SERVICE INFORMATION LETTER

SERVICE INFORMATION LETTER INDEX

FIGURE 4A

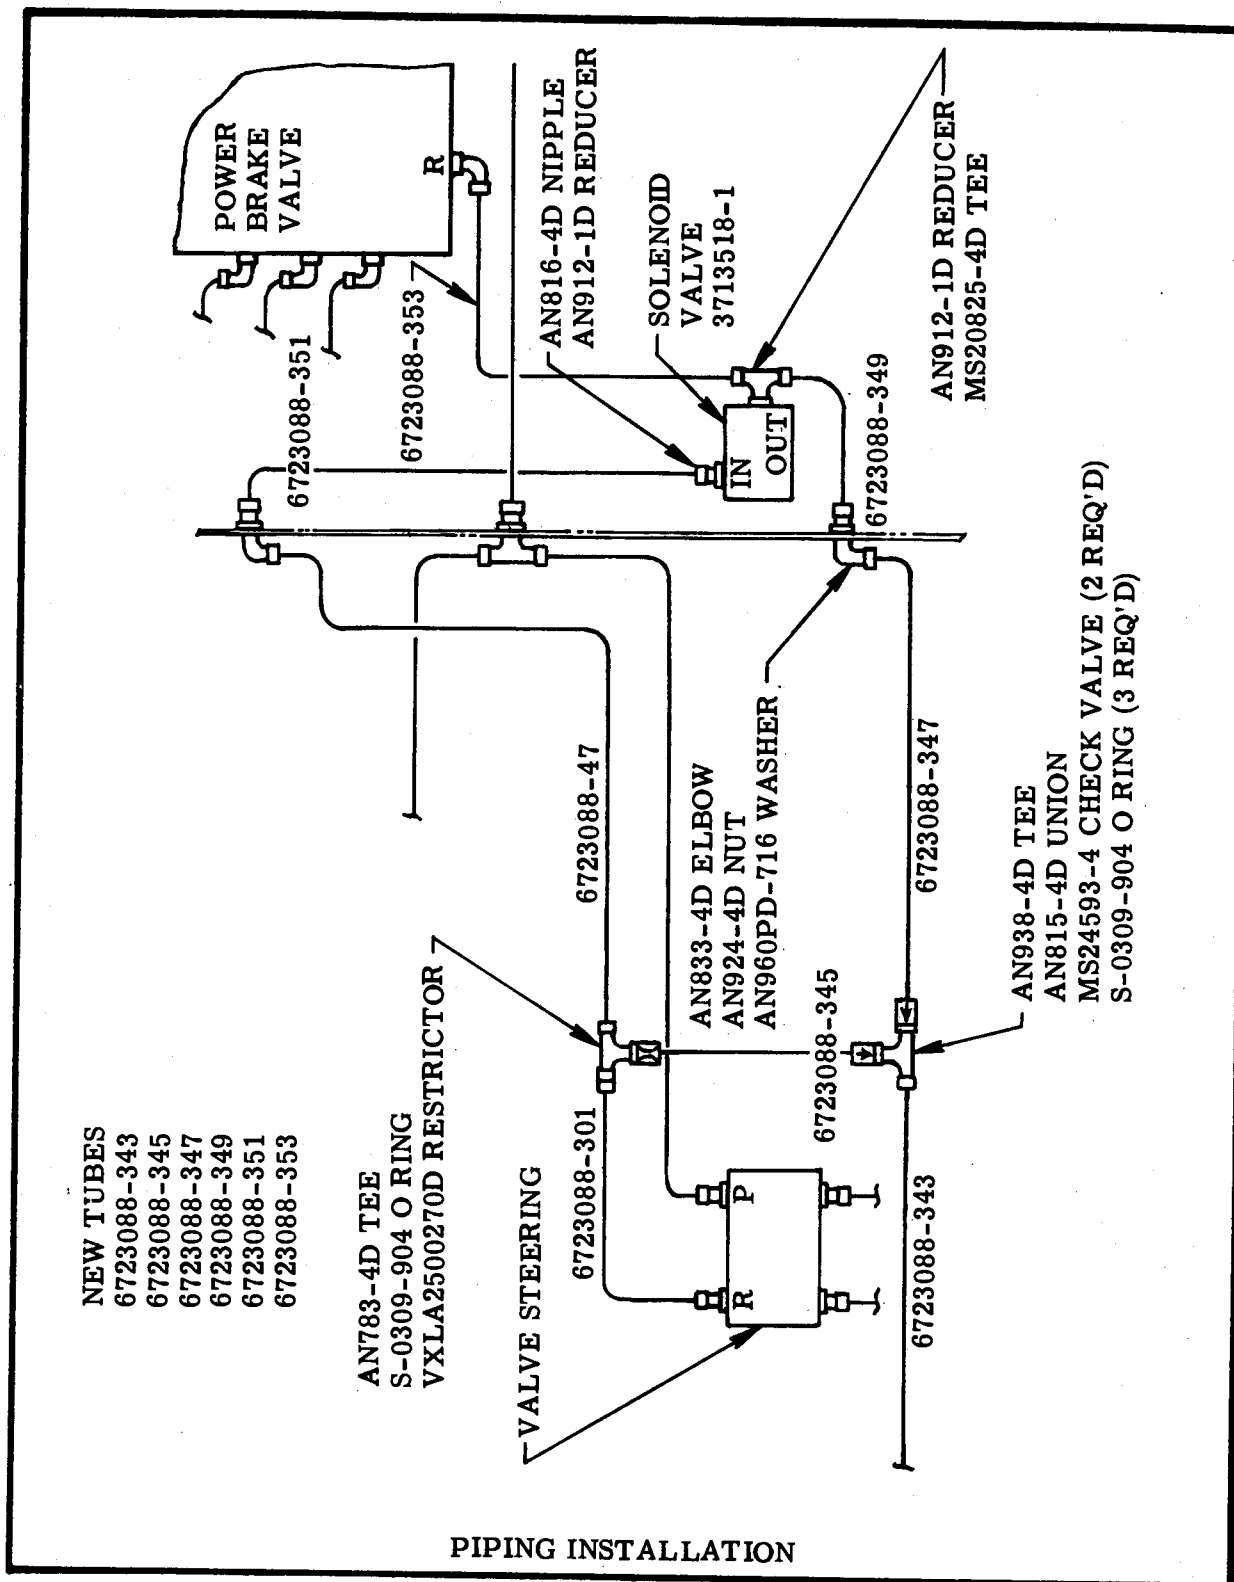
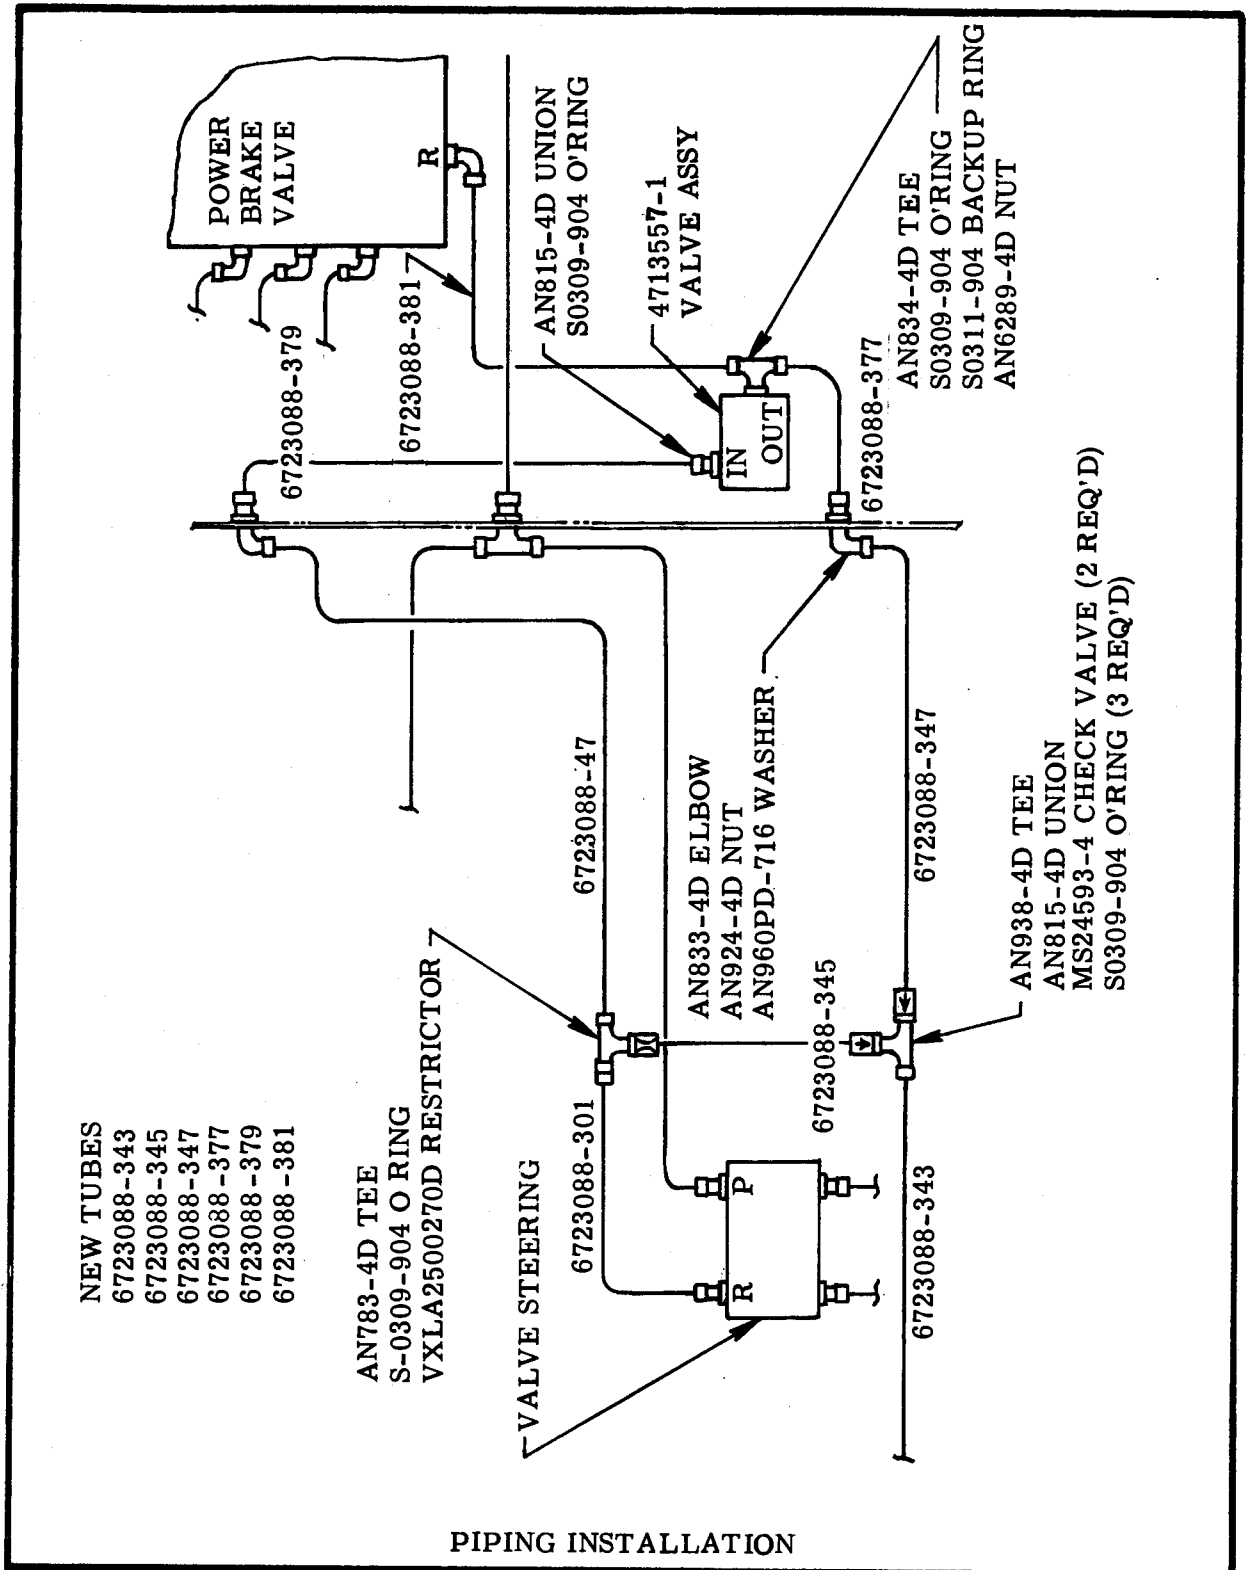
16. Install the AN783-4D tee between the -47 and -301 tube assys, in lieu of the AN938-4D tee removed in Step 14 B, as per Schematic Figure 4.
17. Refer to piping installation Schematic Figure 4 (Kit "A") or Figure 4A (Kit "B"), and install new hydraulic return tubing between the nose steering valve, solenoid valve, power brake valve, and the hydraulic return tube at the AN824-6D tee and the 6-TRTX-D reducer, as per schematic.

FIGURE 1

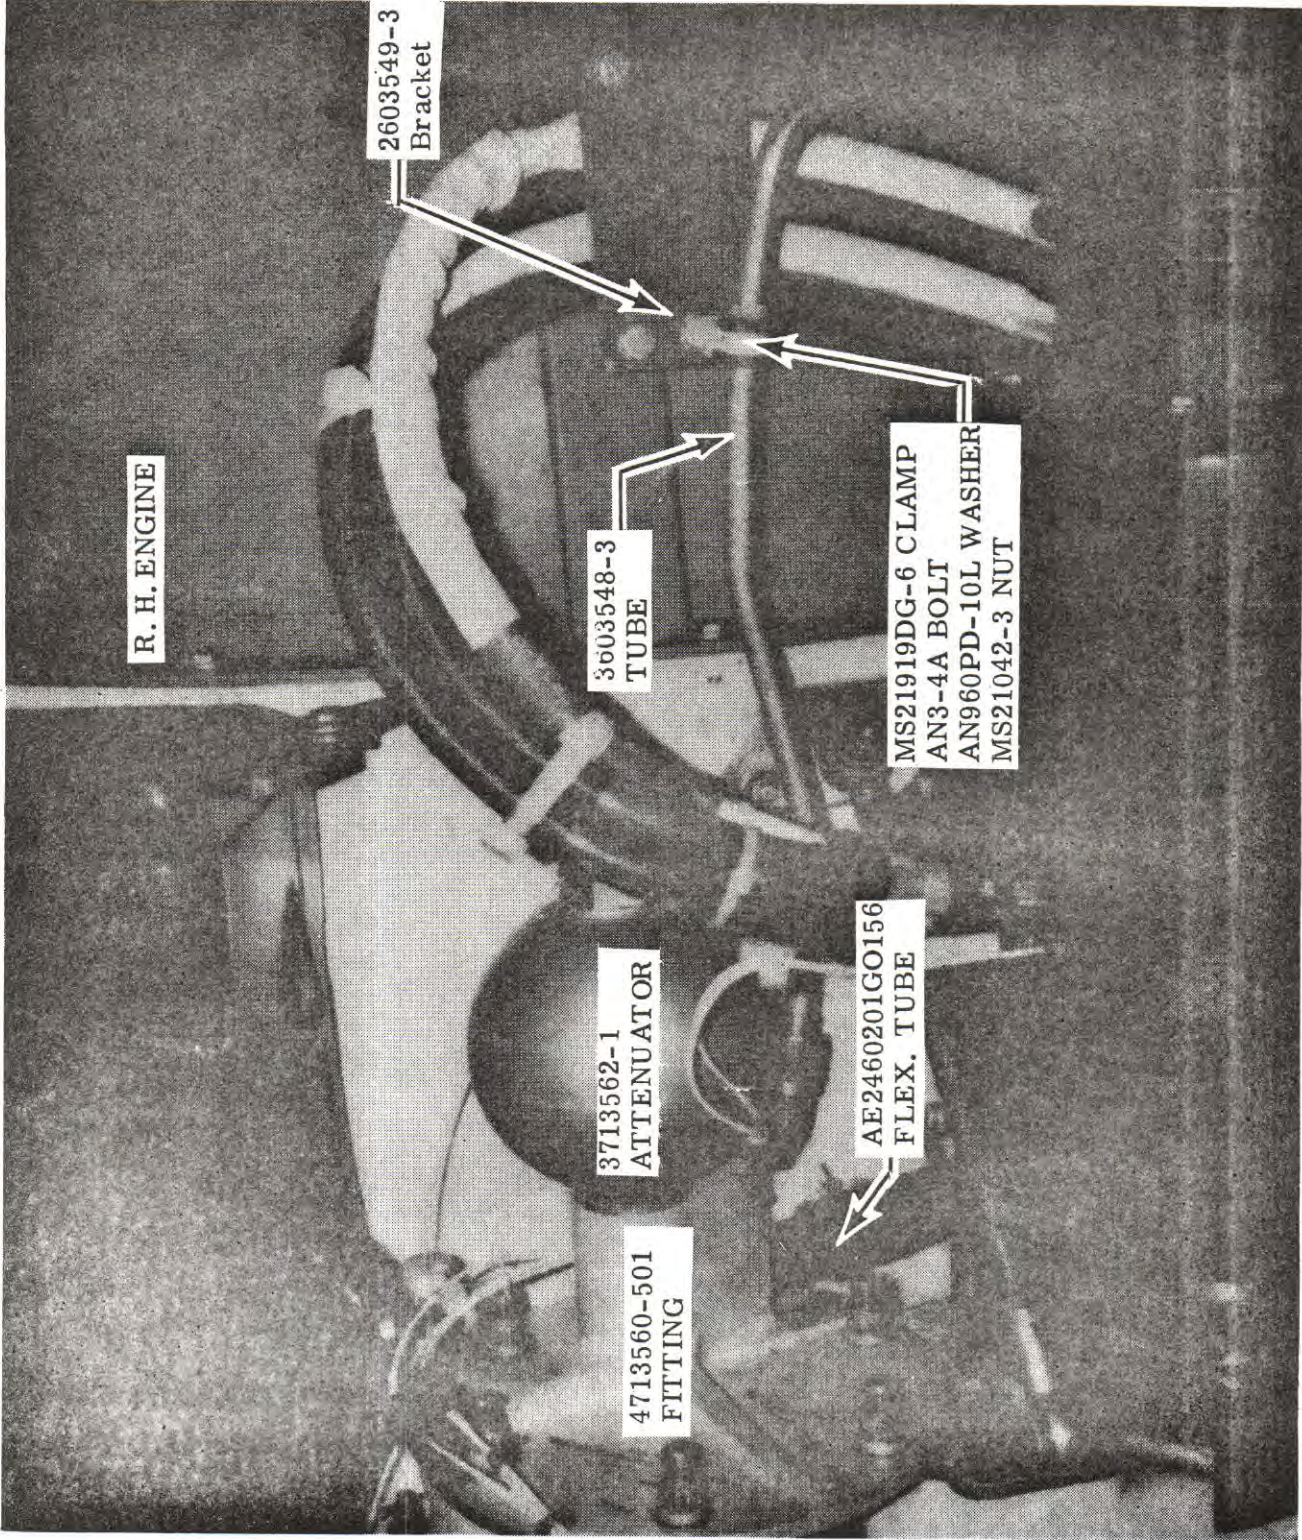
10. Remove and discard existing bracket P/N F10A-5-L20025-9, from right engine nacelle and replace with new bracket P/N 3603547-1. (See Figure 1).
11. Install an AN837-6J elbow, AN960C-916 washer, and AN924-6J nut on plate of bracket P/N 3603547-1, per Figure 1.

12. Install new flexible hose P/N AE2460201GO156 between R. H. hydraulic pump and inlet port of fitting P/N 4713560-501. (See Figures 1 and 2).
13. Secure hose to hydraulic pump mounting pad, with MS21919DG-14 clamp, AN3-4A bolt, AN960PD-10L washer, MS21042-3 nut and 2603550-3 bracket, per Figure 4.

FIGURE 2

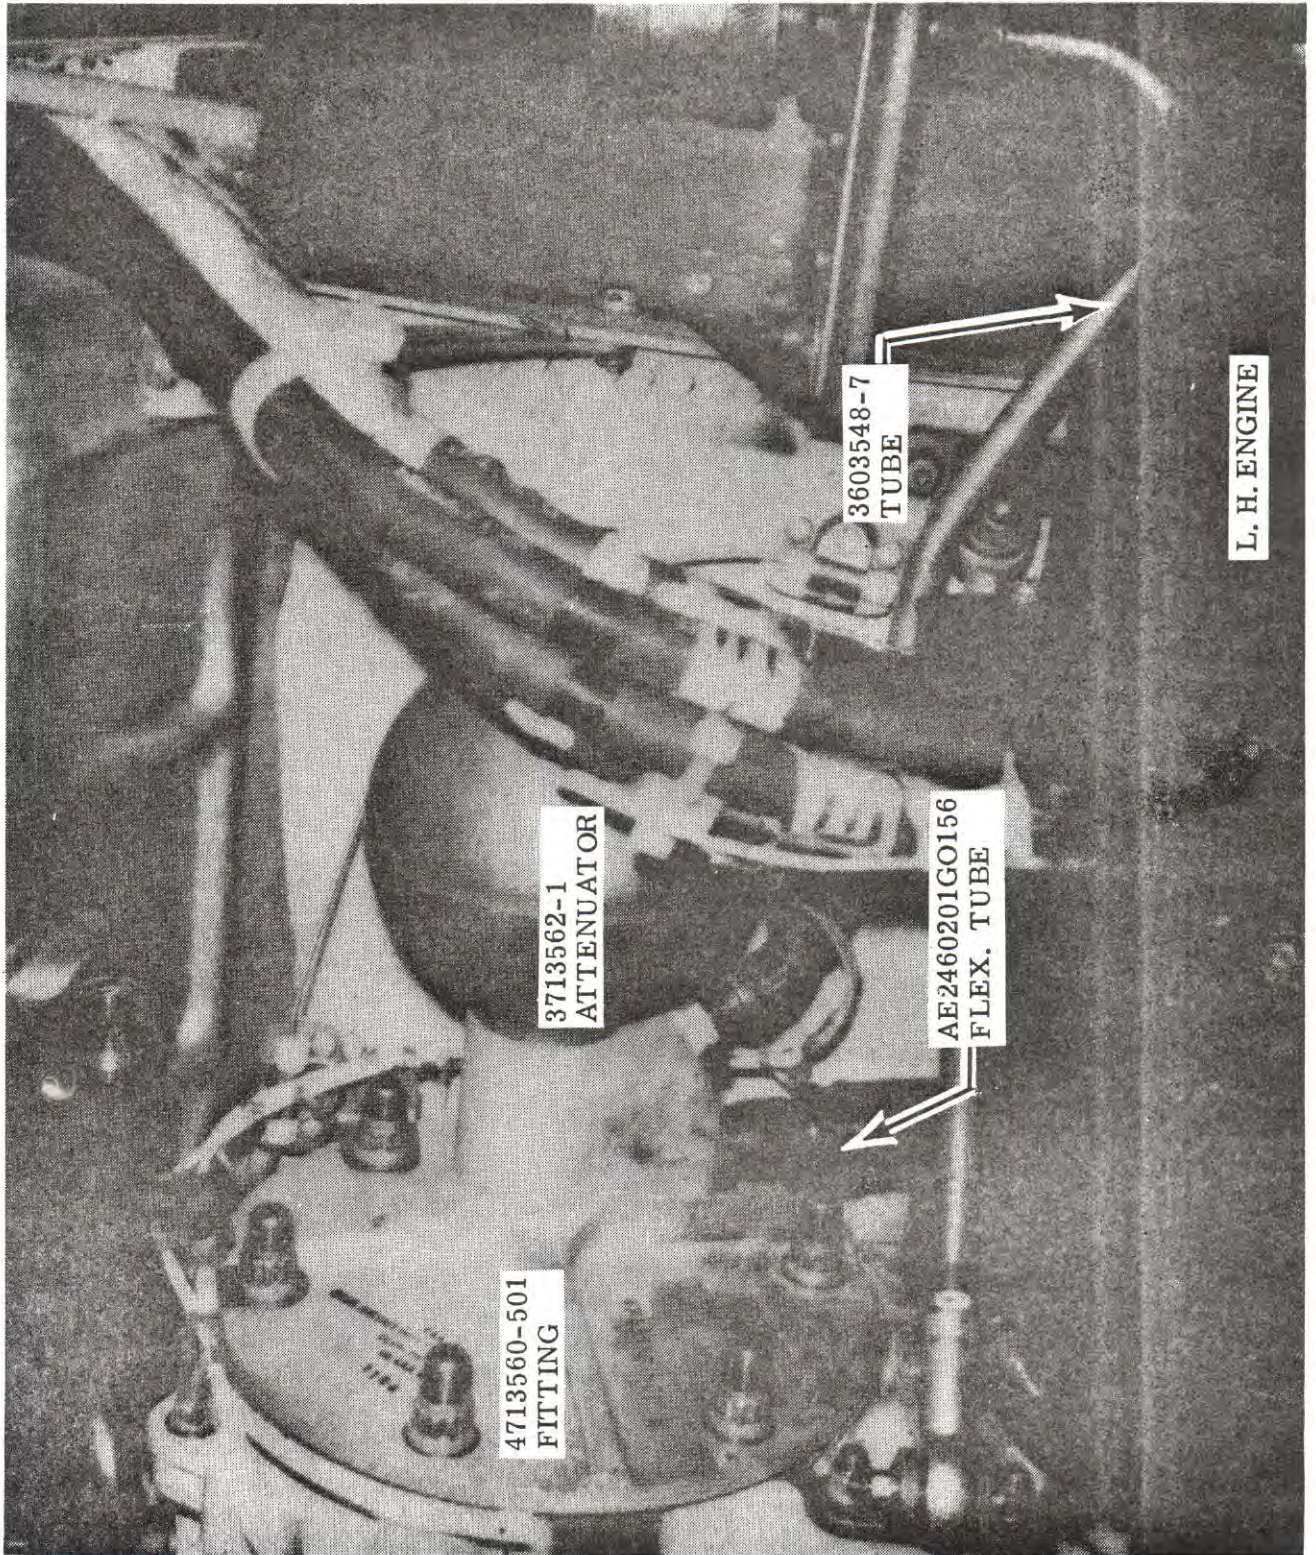
14. Install new tube P/N 3603548-3 between outlet port of fitting P/N 4714560-501 and the AN837-6J elbow, which was installed in Step 11.
15. Secure tube to wiring support block with MS21919DG-6 clamp, AN3-4A bolt, AN960PD-10L washer, MS21042-3 nut, and 2603549-3 bracket, per Figure 2.

FIGURE 3

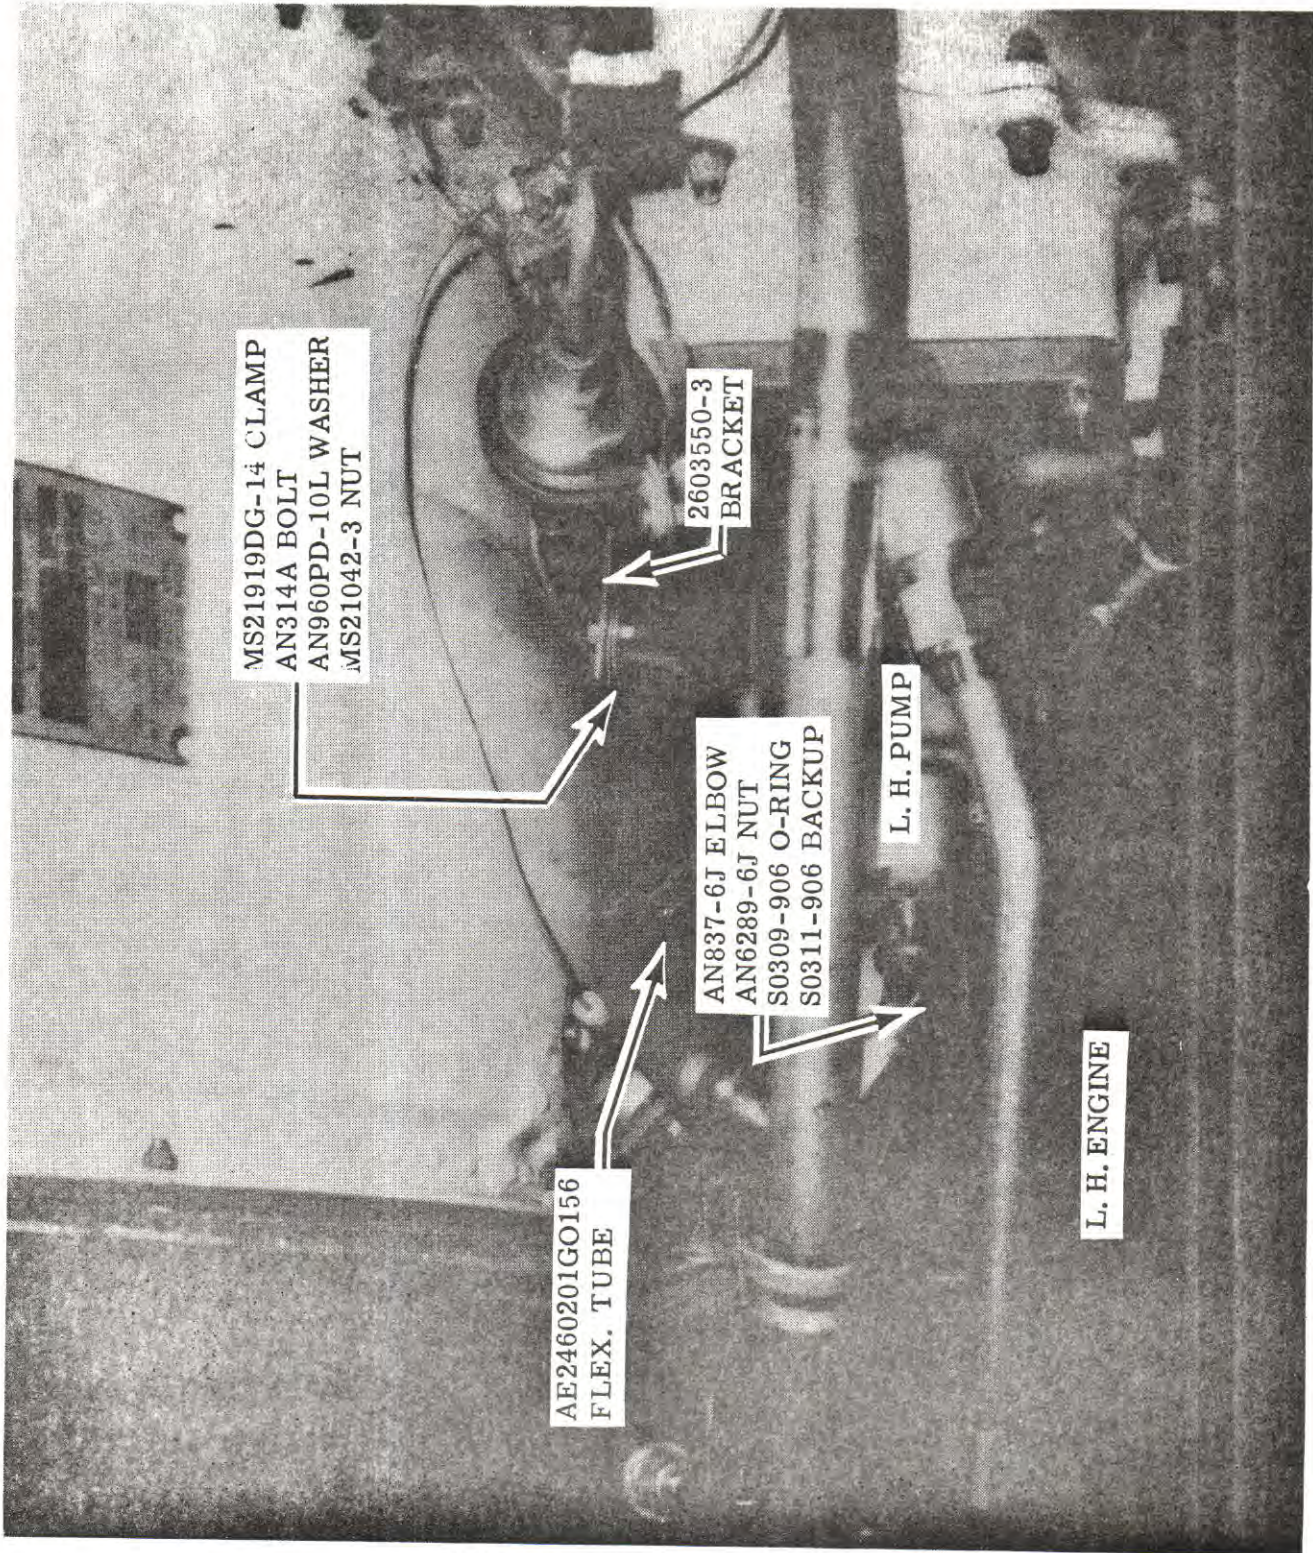
19. Install new tube P/N 3603548-7 between outlet port of fitting P/N 4713560-501 and quick disconnect fitting, per Figure 3.
20. Refer to Figure 6 and install a sleeve P/N 3713561-501, attenuator P/N 3713562-1, with a S0309-910 O-ring on each accessory drive pad fitting P/N 4713560-501. Torque and safety wire attenuators, per Figure 3.
